Service Bulletin

Subject	Parts Change Information.			
Model	TASKalfa500ci, TASKalfa400ci, TASKalfa300ci, TASKalfa250ci, TASKalfa420i, TASKalfa520i, TASKalfa180, TASKalfa220, TASKalfa181, TASKalfa221, KM-2531/2530, KM-3531/3530, KM-4031/4030, FS-9100DN, FS-9500DN, KM-3035, KM-4035, KM-5035, FS-9120DN, FS-9520DN, KM-3050, KM-4050, KM-5050, FS-9130DN, FS-9530DN, EP 510DN, KM-2560, KM-3060, KM-2640, KM-3040

Ref. No. **PCI-0222 (9009)**

<Improving production efficiency (PULLEY SCANNER) → After using up the old stock>

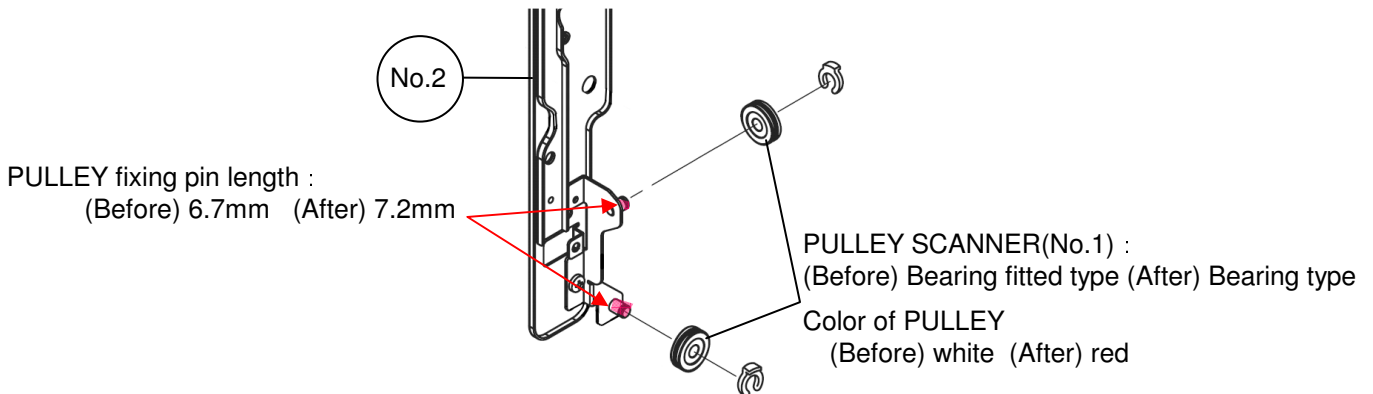
According to the change, thickness of PULLEY (No2) changes from max5.6mm to max6.1mm.

<Change of shape of FRAME EXIT UPPER

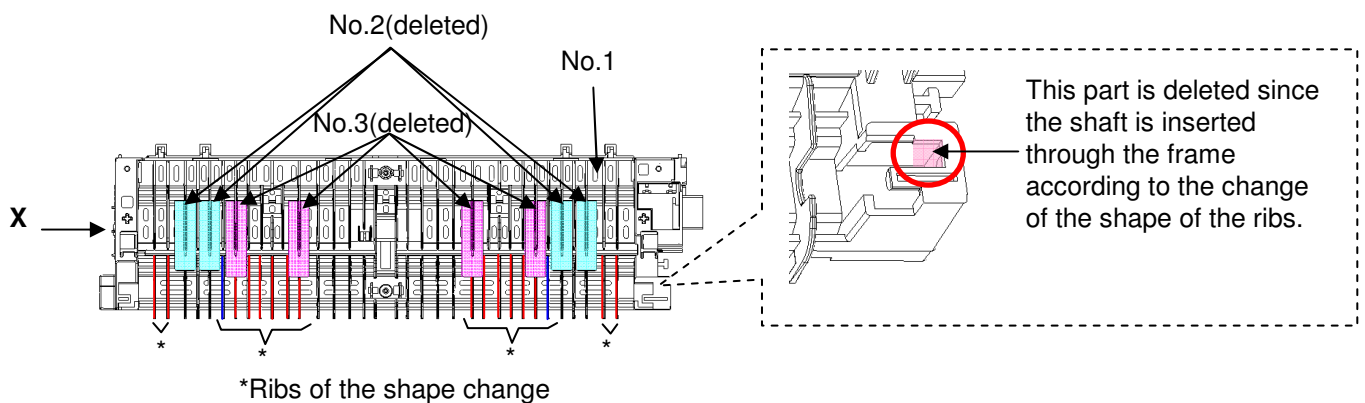
- 1) Shape of the ribs are changed (added or cut) to prevent the dog ear generated at the gap between the roller shaft and the rib.
- 2) SHEET EXIT(No.1) and SHEET EXIT B(No.2) are deleted according to the change.

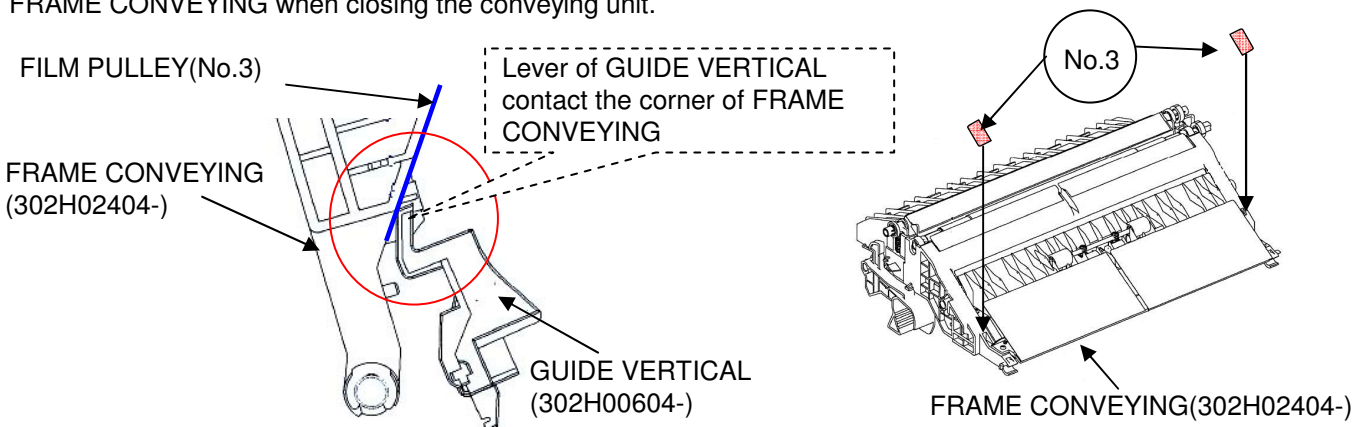
FILM PULLEY(No.3) is added to the point where the lever of GUIDE VERTICAL may contact the corner of FRAME CONVEYING when closing the conveying unit.

<Content of changes>

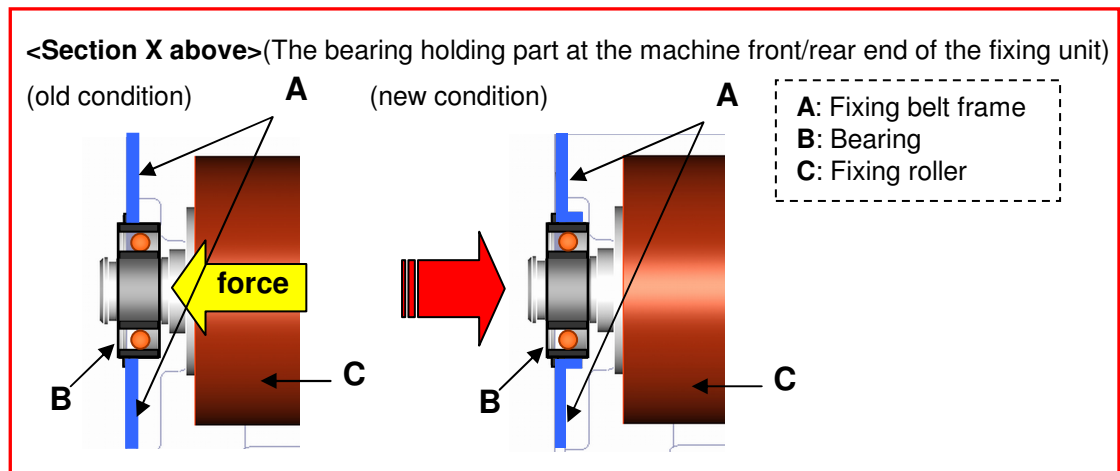
The grease that is applied to the inner part of the bearing to reduce the friction between the fixing roller shaft and the inner part of the bearing is changed to heat resistant type to avoid deterioration by the fixing heat and (applied since August 2009 production)

Draw shape is applied to the part to hold the bearing on the fixing belt frame to improve holding of the bearing. (planned in November 2009 production)

[Change 2 Avoiding the contact with the staple unit that is at the new migrating position]

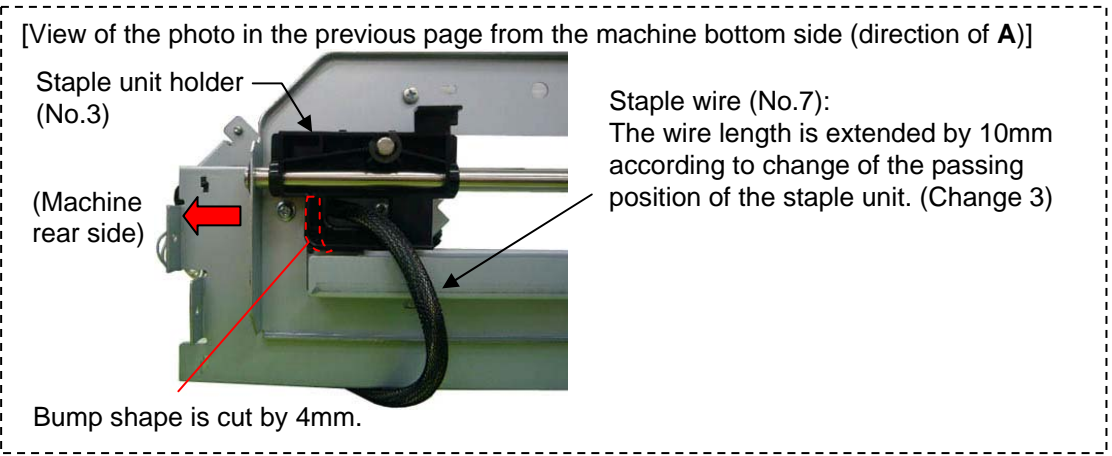
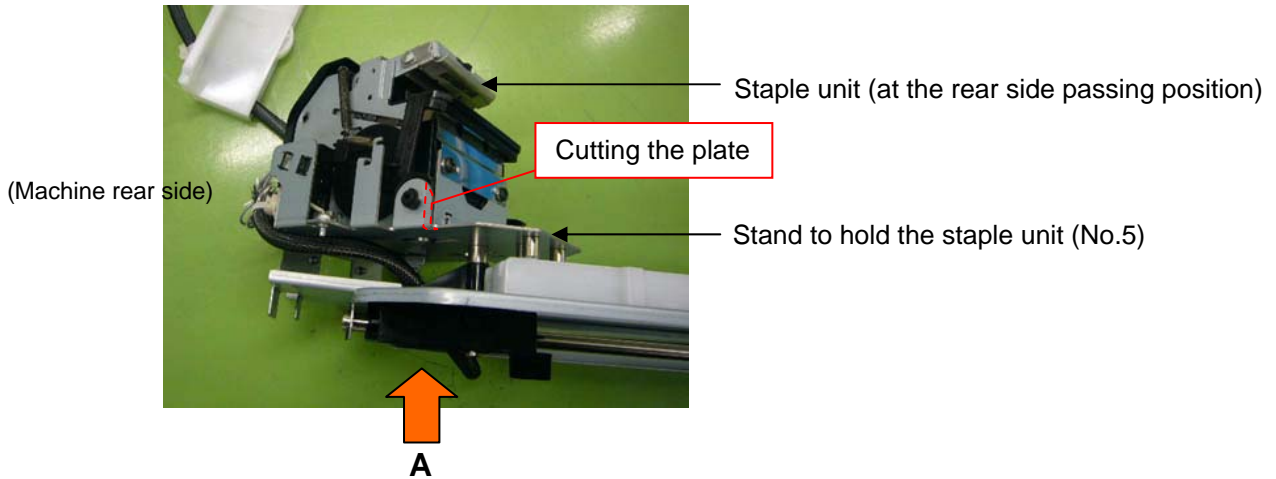
<Staple unit slide section at the machine rear side> (Below is the old shape)

New rear frame
(It is not supplied in the field)
: - The hole for migrating the staple unit is expanded. (Change 2)
- The hole for fitting the RDHS wire alignment part (No.9) is added. (Change 3)

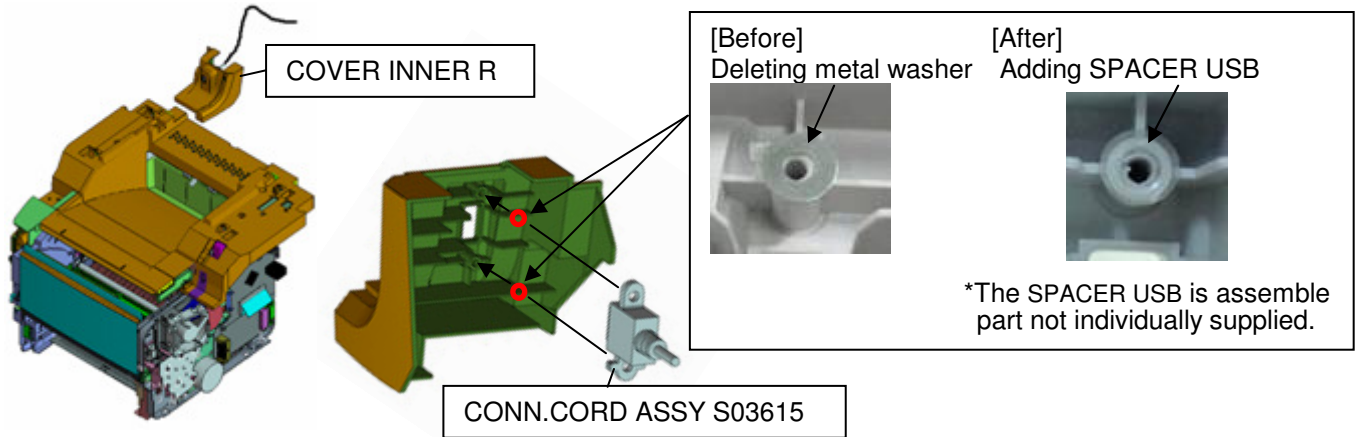
The boss on COVER INNER R may be broken where CONN.CORD ASSY S03615 contact.
For strengthening COVER INNER R, 2 pcs of SPASER USB are added.
According to this change, the part code remains unchanged.

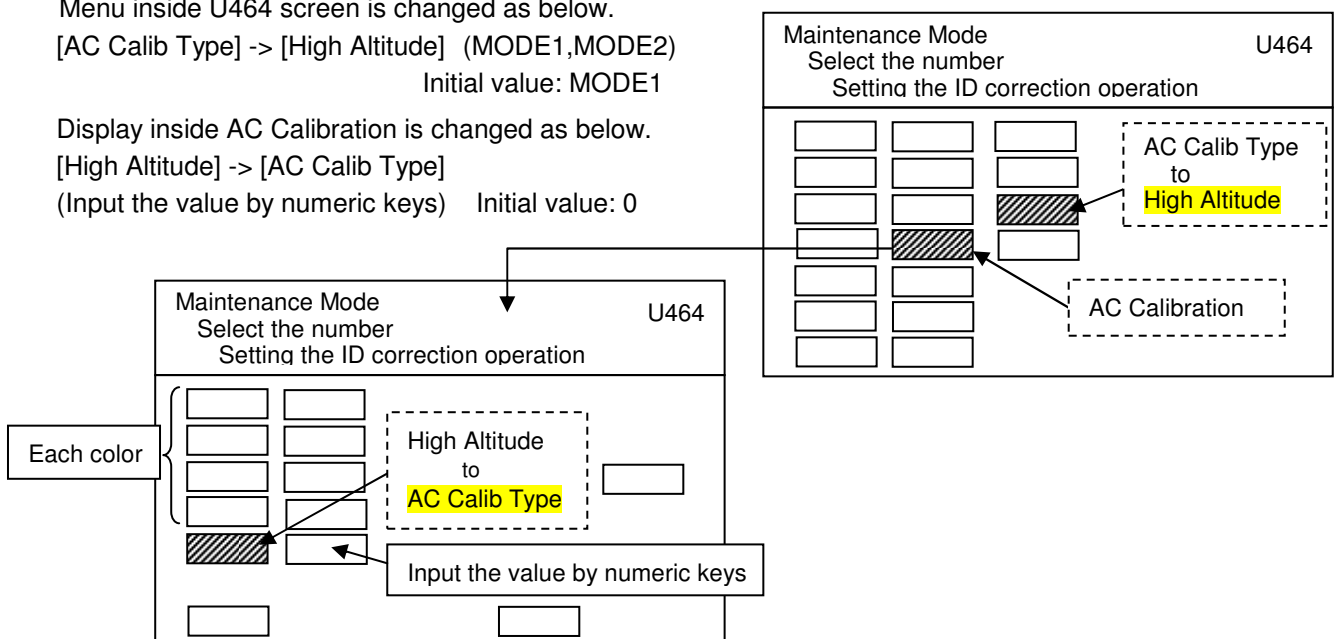
Menu inside U464 screen is changed as below.

[AC Calib Type] -> [High Altitude] (MODE1,MODE2)

<State with the old fuser guide (Cross-section view)>
(Before)

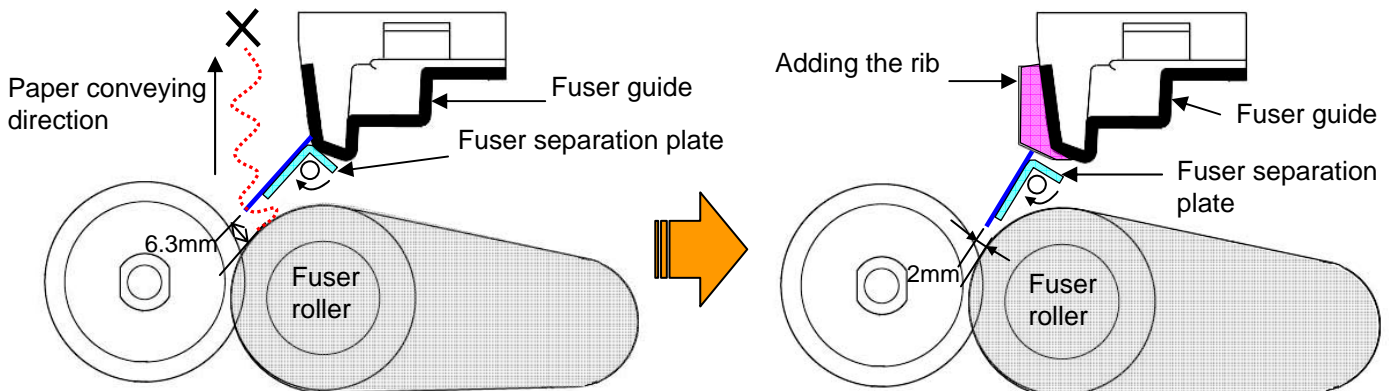
<State with the fuser guide adding the rib (Cross-section view)>
(After)

[Machine front side of the Bk developing unit]

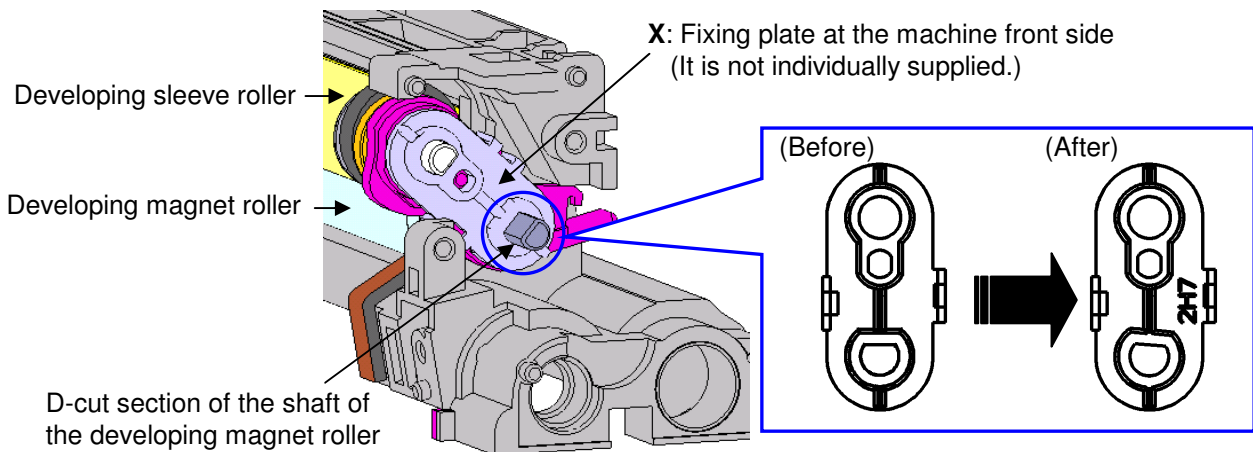
To suit the position of the developing sleeve roller and the developing magnet roller, angle of the D-cut hole in the fixing plate (X in the figure below) at the machine front side that secures the attachment angle of the developing magnet roller is changed so that the image failure in the high humidity environment is improved.

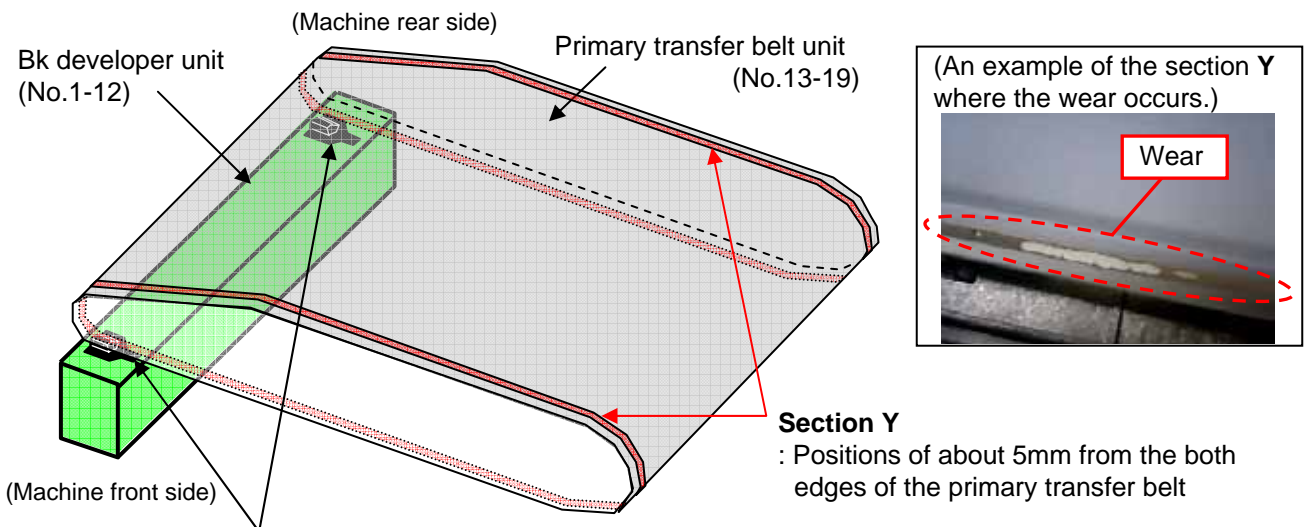
Material of the seal (X: No.20) on the topside of the Bk developer unit is changed to the one with lower friction resistance than before to reduce the wear of the section Y of the primary transfer belt.

Material of the seal: (Before) Seal planted nylon fiber (Black) --> (After) Fujiron (Teflon felt) (Dark brown)

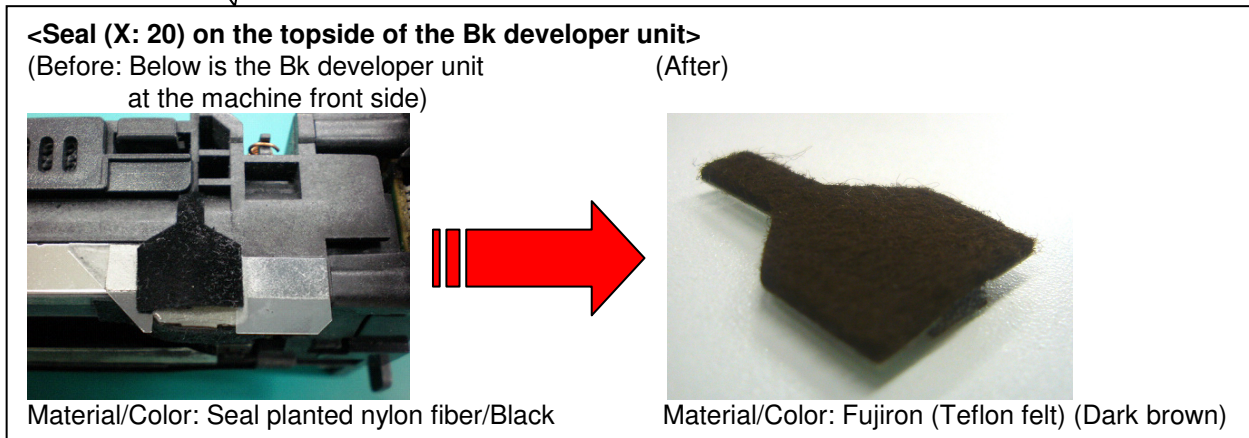
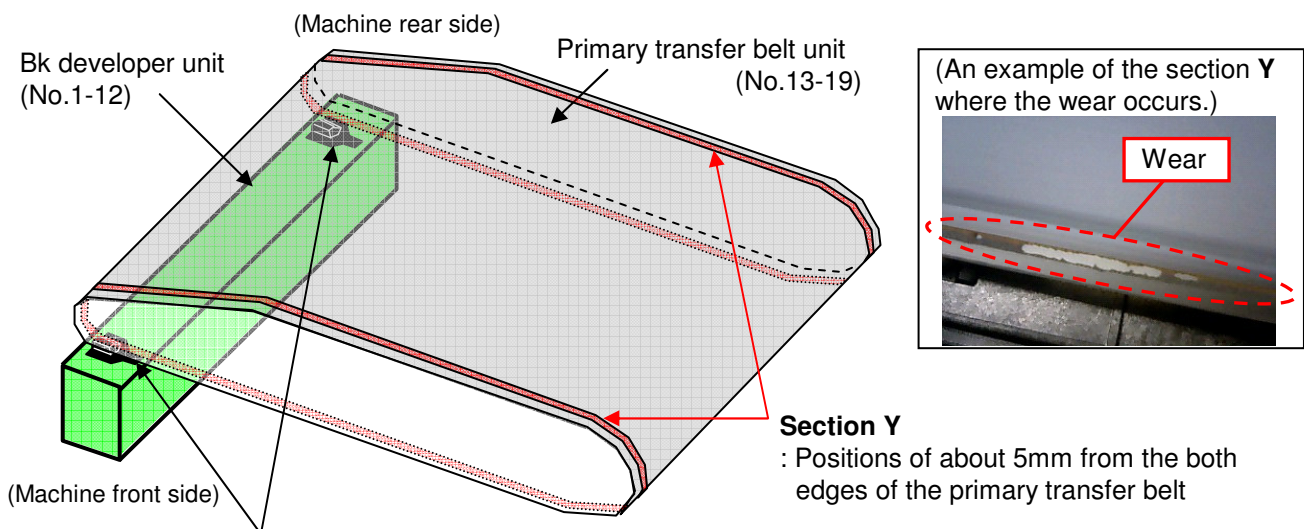
Material of the seal (X: No.20) on the topside of the Bk developer unit is changed to the one with lower friction resistance than before to reduce the wear of the section Y of the primary transfer belt.

Material of the seal: (Before) Seal planted nylon fiber (Black) --> (After) Fujiron (Teflon felt) (Dark brown)

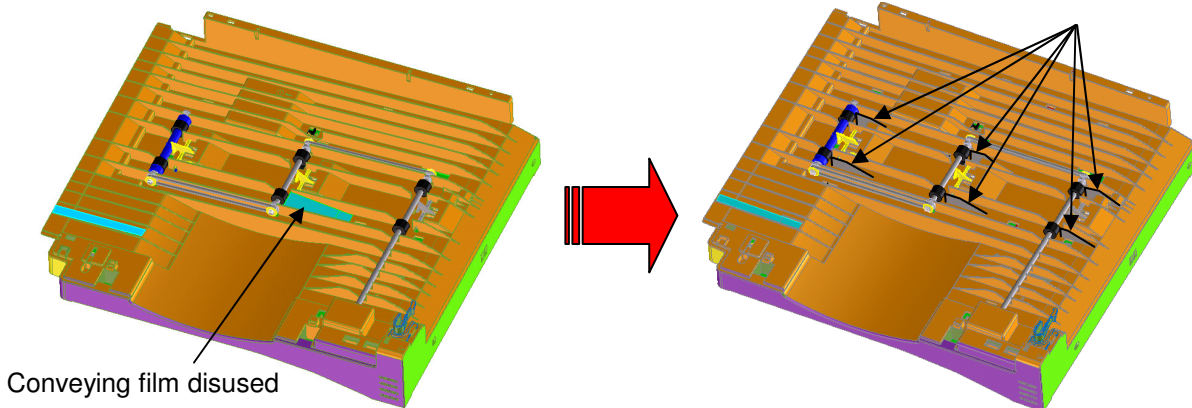
6 points of conveying ribs are added to the lower guide (*) of the bridge unit (AK-470) and the conveying film (*) is disused that is affixed before the center conveying roller in order to improve assembly process.

<PARTS UNIT LOW VOLTAGE 200 SP(No.1)>

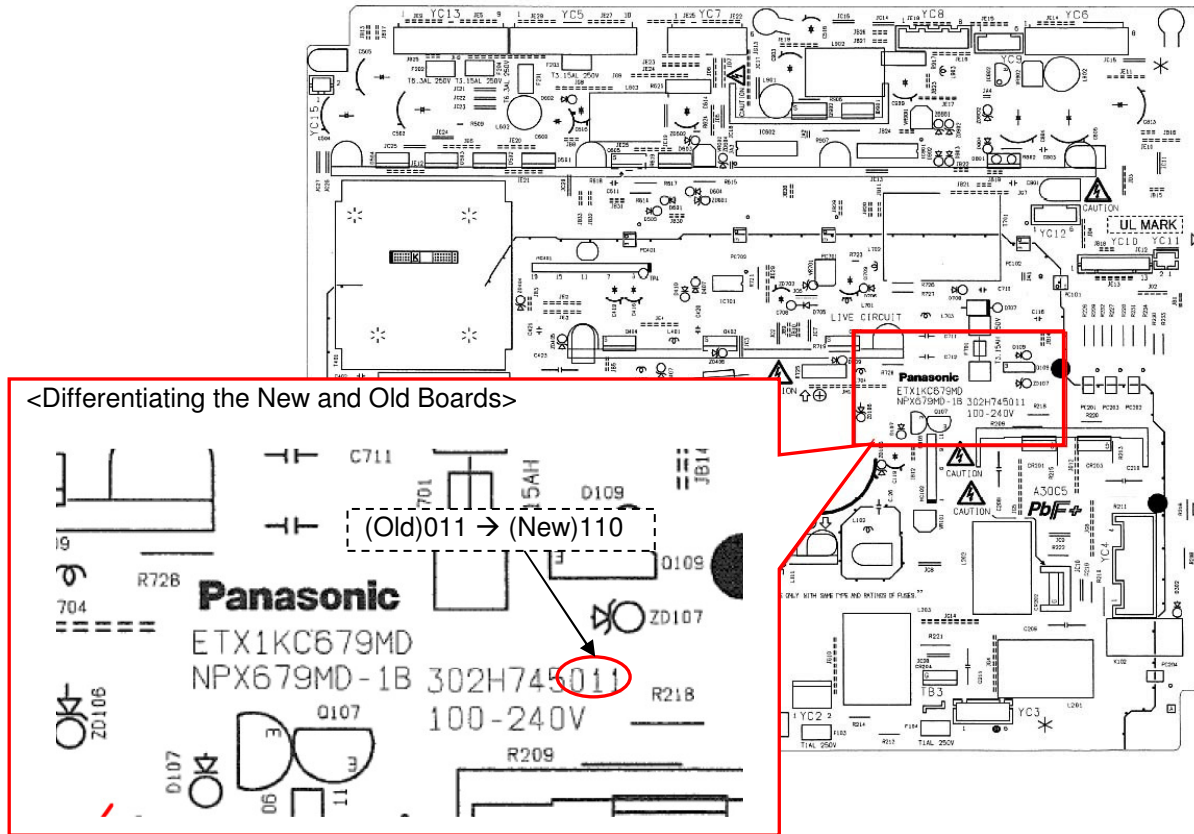
1) In order to increase the margin for the Zero Cross Pulse, the resistance of Board(No.1) has been changed from 100kΩ to 12kΩ.

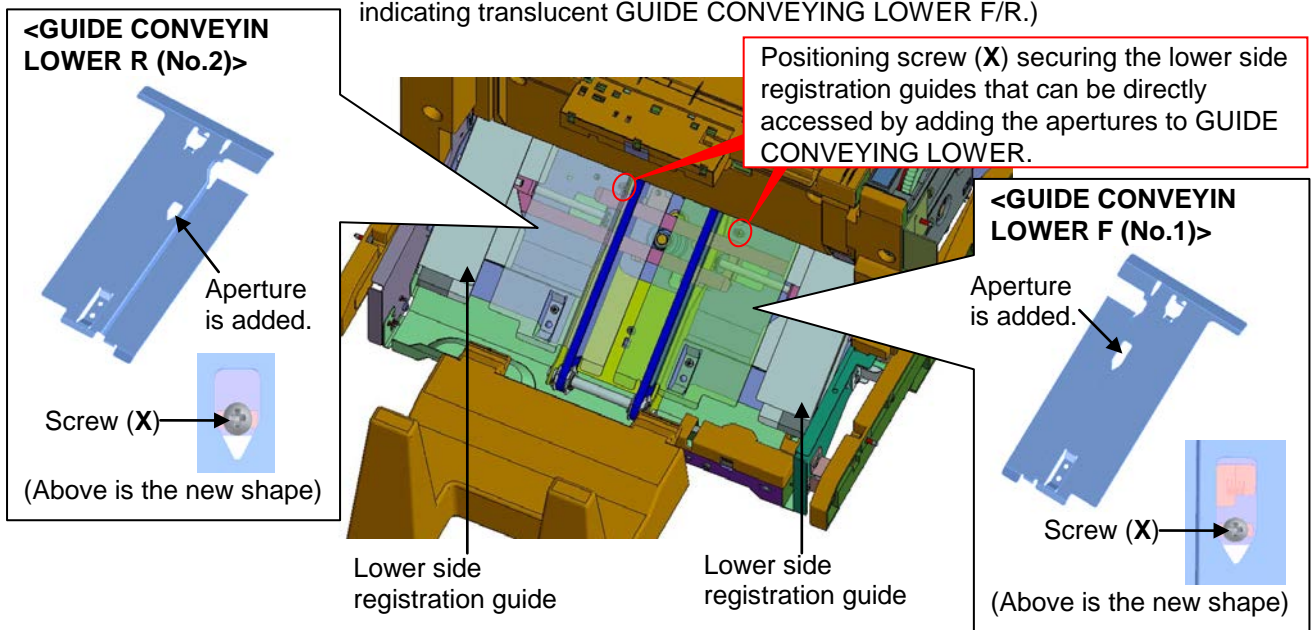
Currently, GUIDE CONVEYING LOWER (No.1, 2) needs to be removed for loosening the positioning screw (X) securing the lower side registration guide when adjusting. At this time, its work becomes unnecessary by adding the apertures to GUIDE CONVEYING LOWER (No.1, 2) in order to directly access the screw.

(Below is the state of removing the unrelated parts like the output tray and of indicating translucent GUIDE CONVEYING LOWER F/R.)
